RE: CHANGE TO APPLICATION AND APPLICANT RESPONSE TO INFORMATION REQUEST REFERENCED AS CA 2025_5880/1 (1363256)

Applicant Response to Information Request

We refer to the Information Request issued by Douglas Shire Council dated 5 May 2026 (Doc ID: 1363256) under Section 12 of the Development Assessment Rules in respect of the above-referenced development application. We thank Council Officers for their detailed review and constructive advice notes.

DRAWING TITLE		
PRELIMINARY PROPERTY ACCESS AND EXTERNAL INTERSECTION VEHICLE SWEEP PATHS LAYOUT PLAN - SHEET 1 OF 3		
PROJECT NUMBER	DRAWING NUMBER	REVISION
BE25041-001	DA205	2

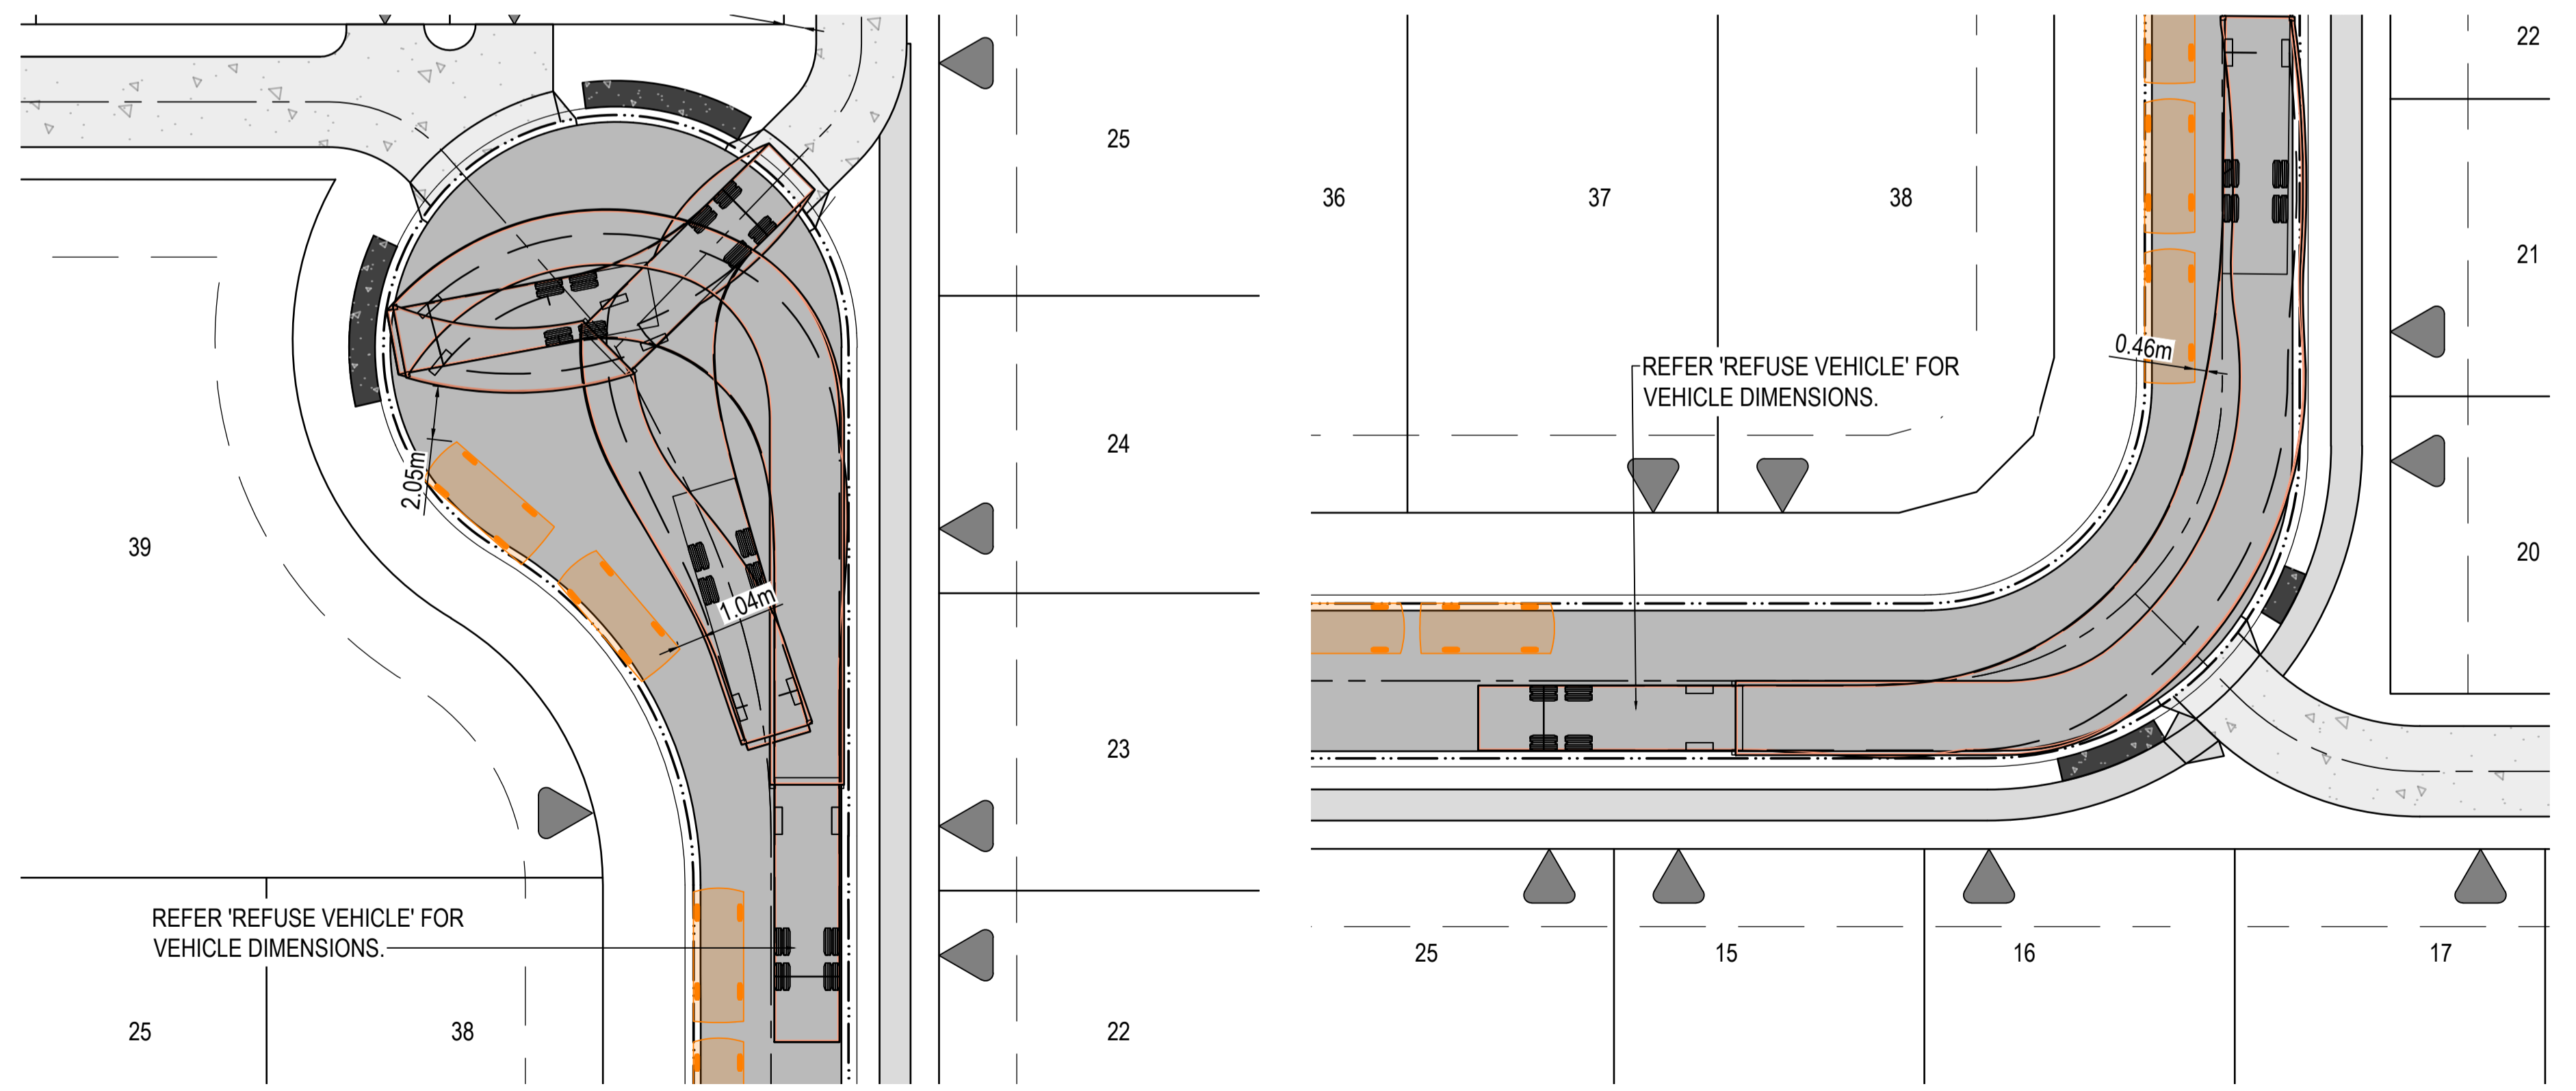
A revised design of the detention basin access and manoeuvring area has been prepared, with a corresponding turn path assessment provided at Drawing DA 205 of the Engineering Services Report at **Attachment 3**.

On-street vehicle parking spaces are designed to accommodate a standard B99 vehicle, as shown in Drawing DA 205 of the Engineering Services Report at **Attachment 3**.

DRAWING TITLE		
PRELIMINARY PROPERTY ACCESS AND EXTERNAL INTERSECTION VEHICLE SWEEP PATHS LAYOUT PLAN - SHEET 2 OF 3		
PROJECT NUMBER	DRAWING NUMBER	REVISION
BE25041-001	DA206	2

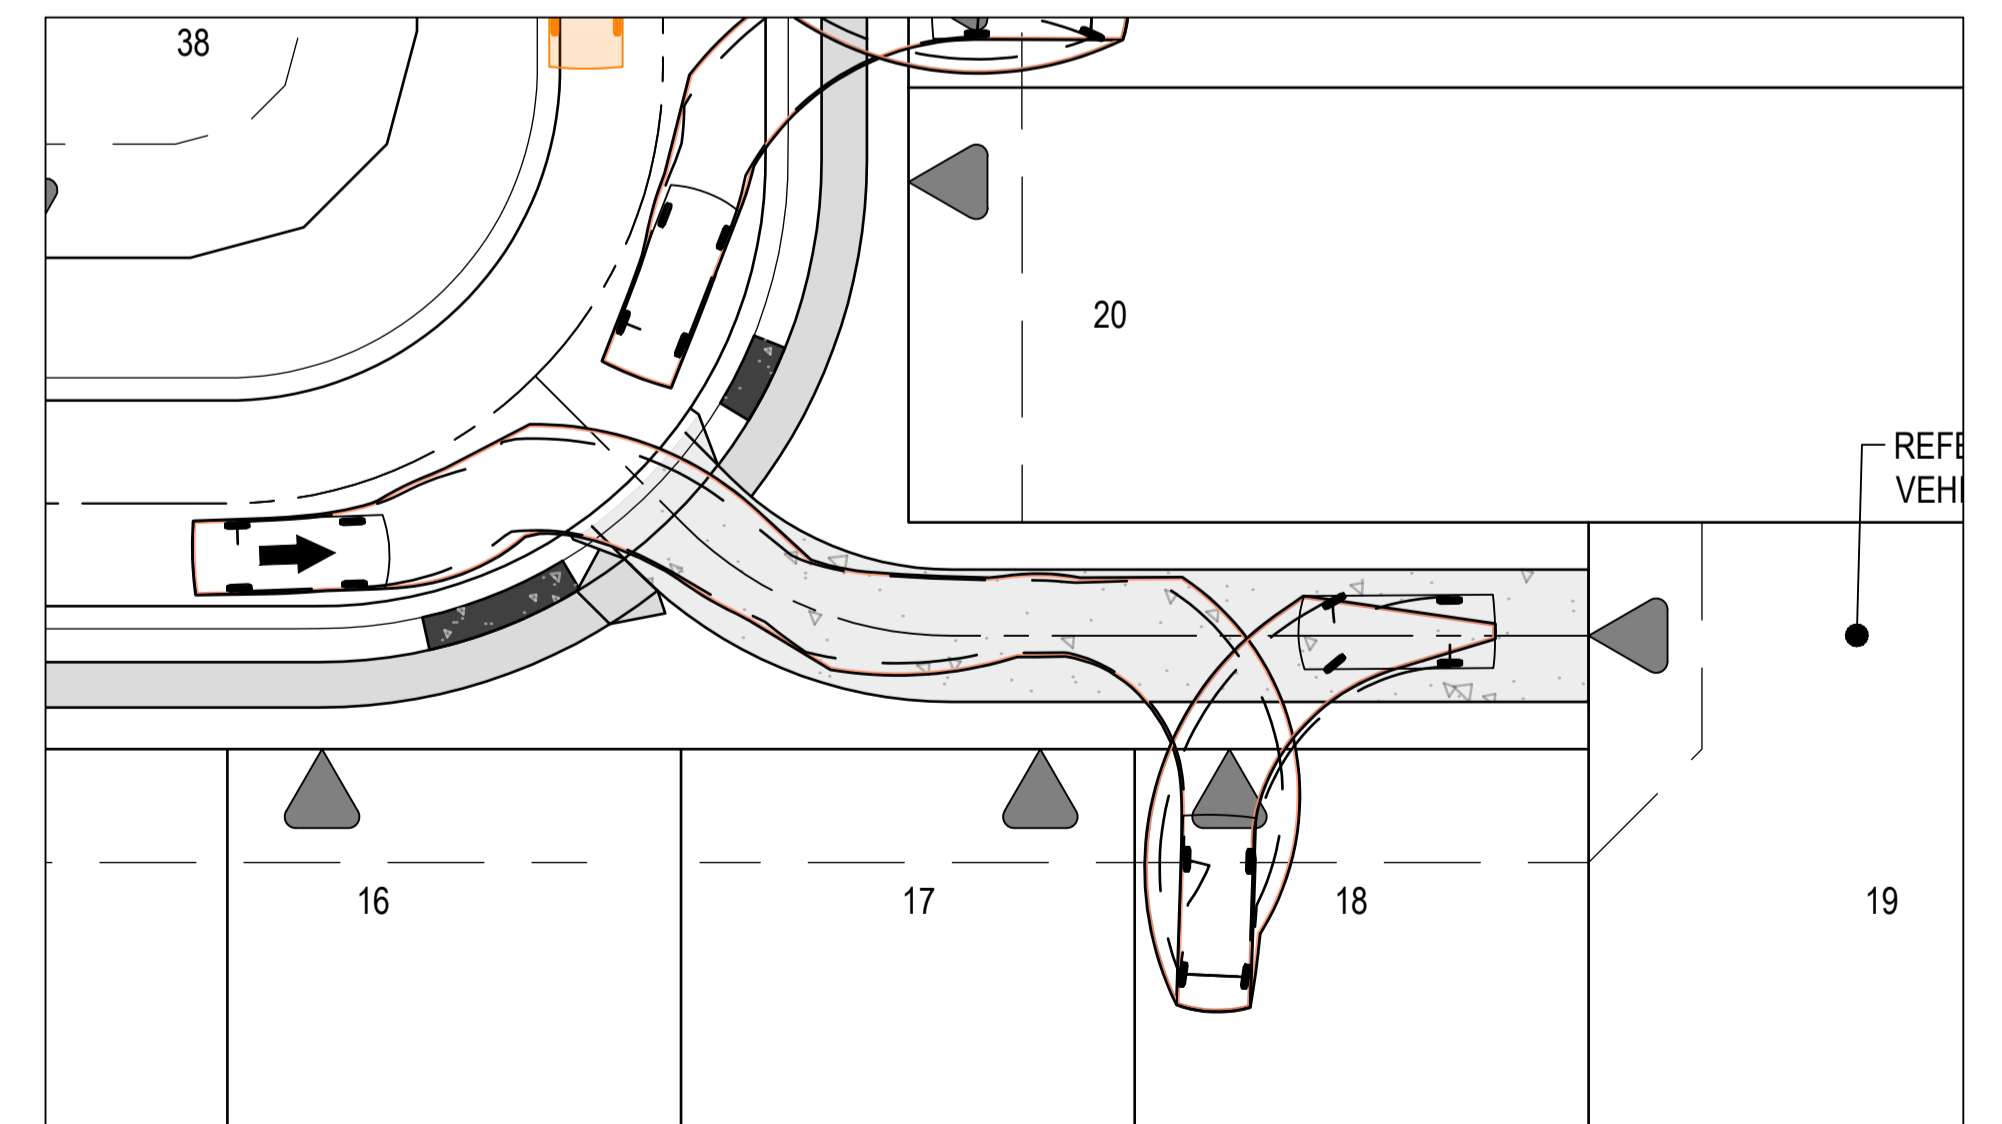
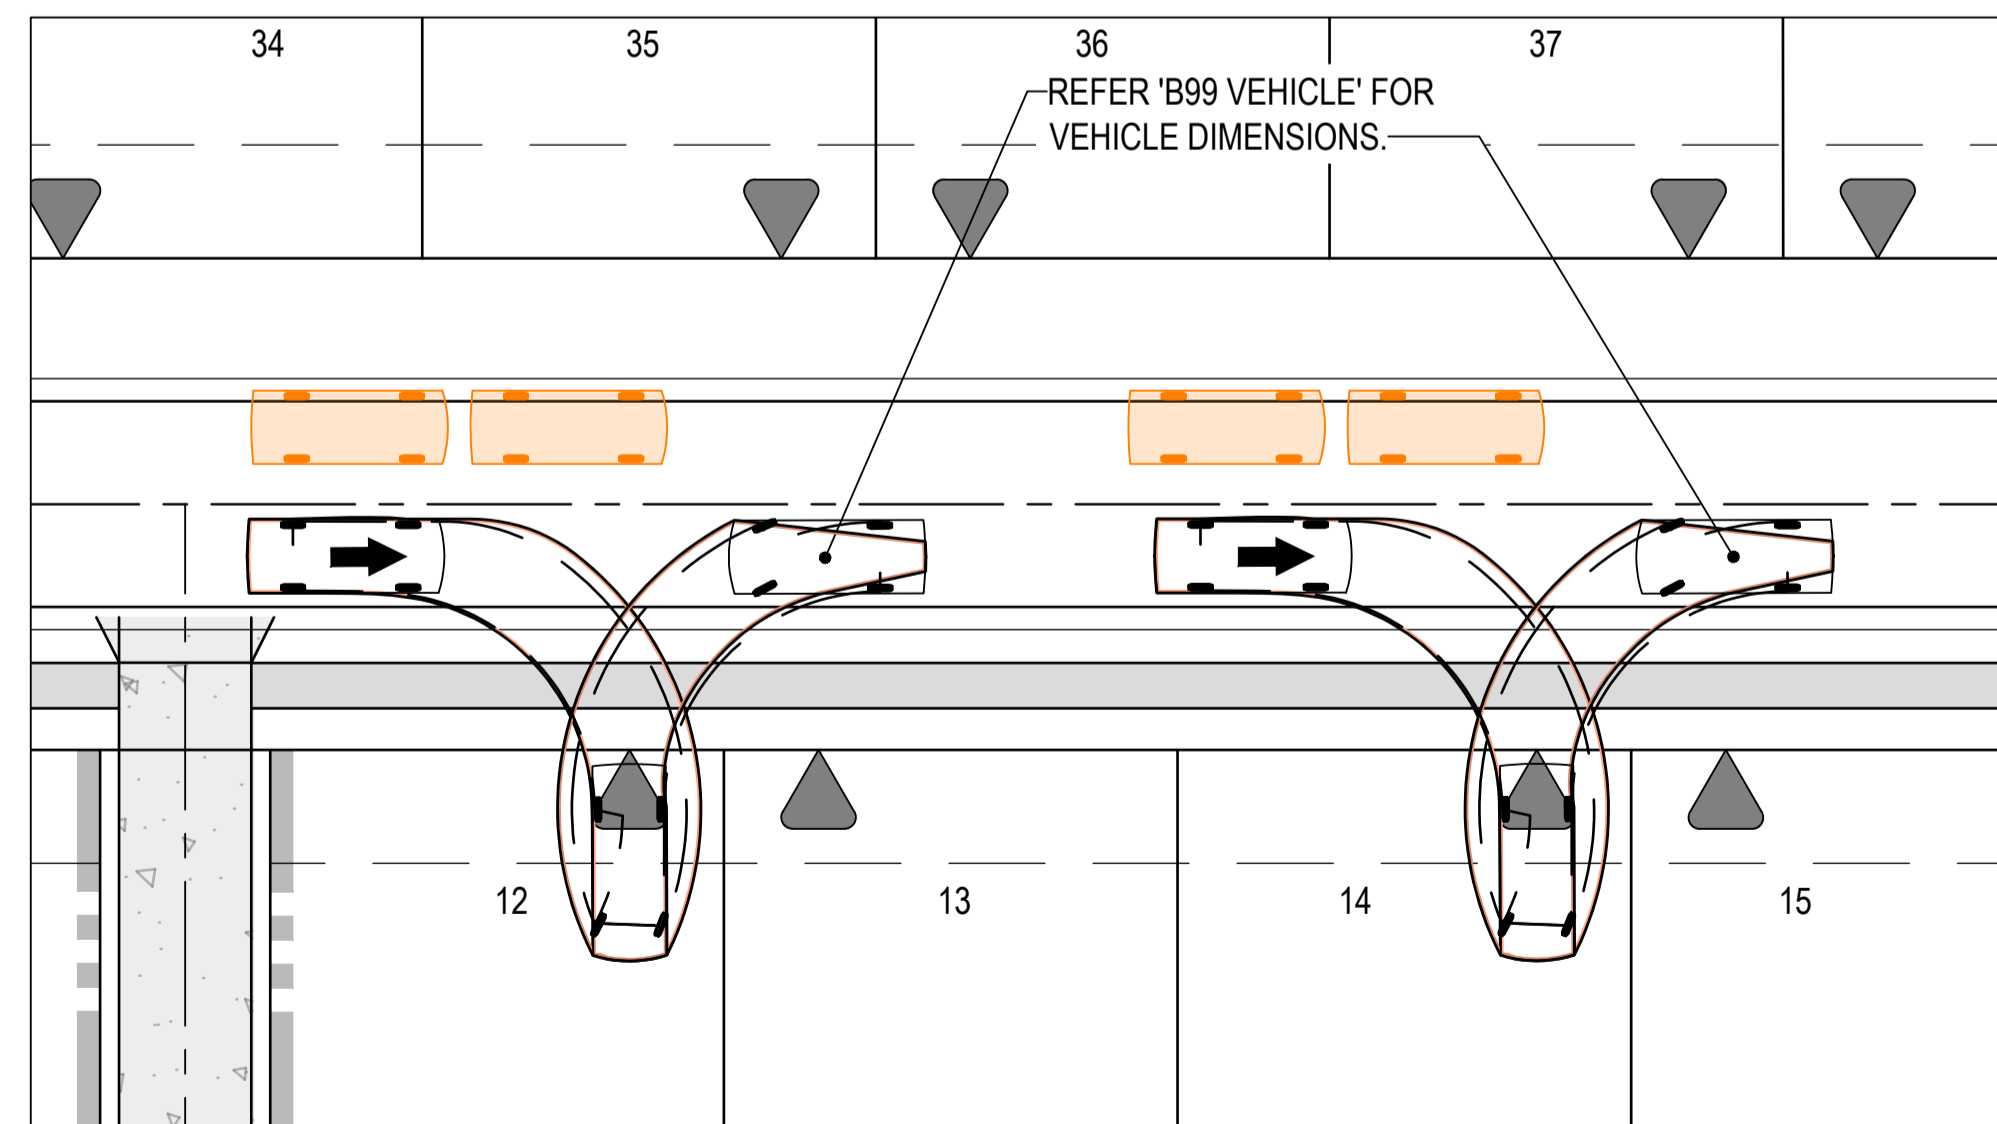
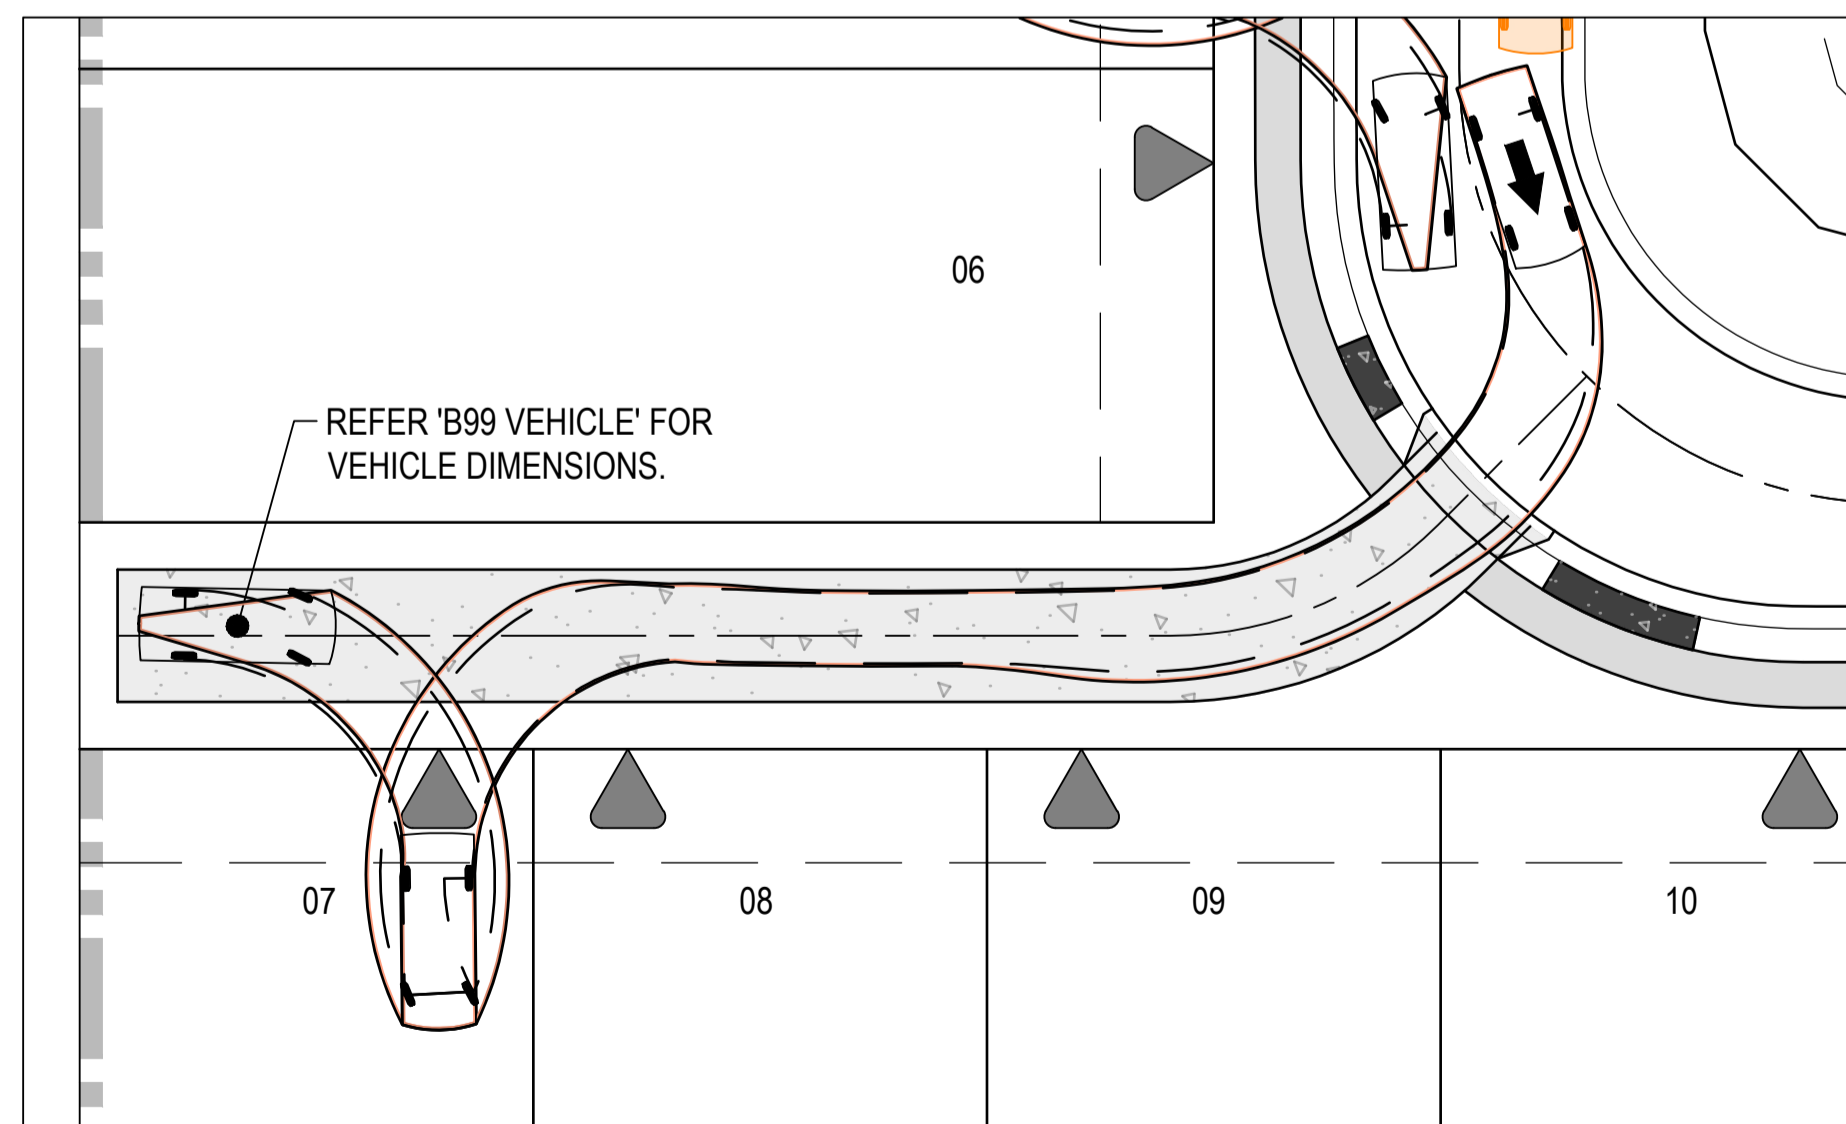
Swept path diagrams supporting the proposed upgrades to the external intersection on Port Douglas Road are provided at Figure DA 206 of the Engineering Services Report at **Attachment 3**. The assessments confirm the design vehicle(s) and check vehicle(s) used, and all diagrams include vehicle clearance linework in accordance with applicable Australian Standards.

Figure 2 Proposed Access Arrangements compared to Previously Approved Site Access Arrangements

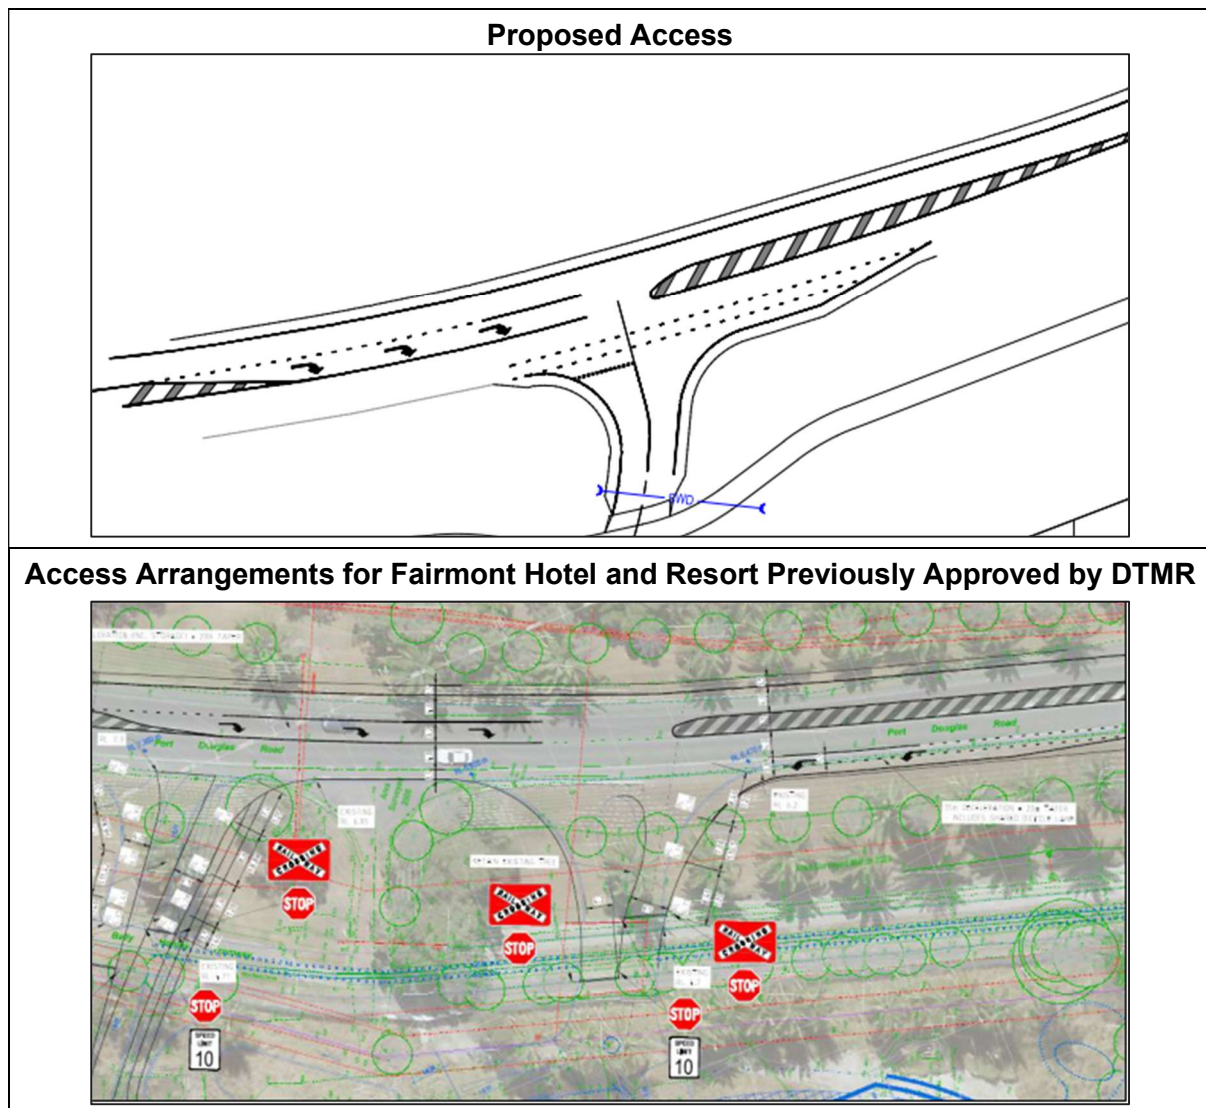
The development access has been amended based on advice from Council's IR (Item 6). It is now proposed that the development will access the site directly via Port Douglas Road, as shown in **Figure 2**. This arrangement is generally in accordance with the access previously approved by DTMR for the Fairmont Hotels and Resort development. An operational assessment has been undertaken for the proposed access, with SIDRA assessment results presented in **Section 5.3** and the Turn Warrant Assessment in **Section 5.4**.
